**Date:** 10/98**Number of Pages:** 1**Reference #:** 00106

**Subject:** In some GM vehicles, a faint extra chirp may be heard when the MS8200/8300 is connected to the positive trigger door locking system.

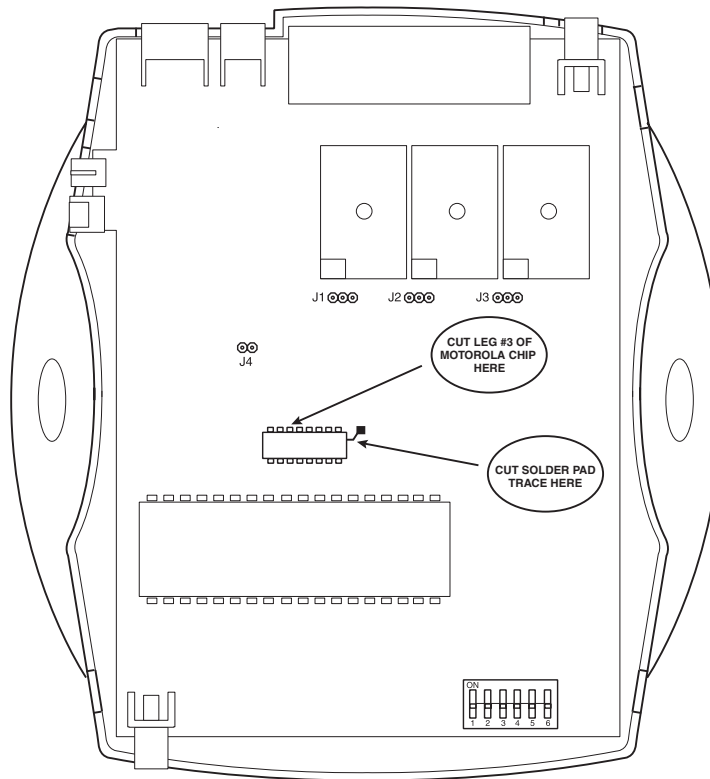
Cut the third leg from the left on the small microchip pictured below. Next cut the trace leading to the solder pad directly next to the microchip. This will eliminate any faint chirps heard when locking the doors either by remote, or with the switch in the vehicle.

Performing this modification will not adversely affect the operation of the MS8200/8300 in any way.
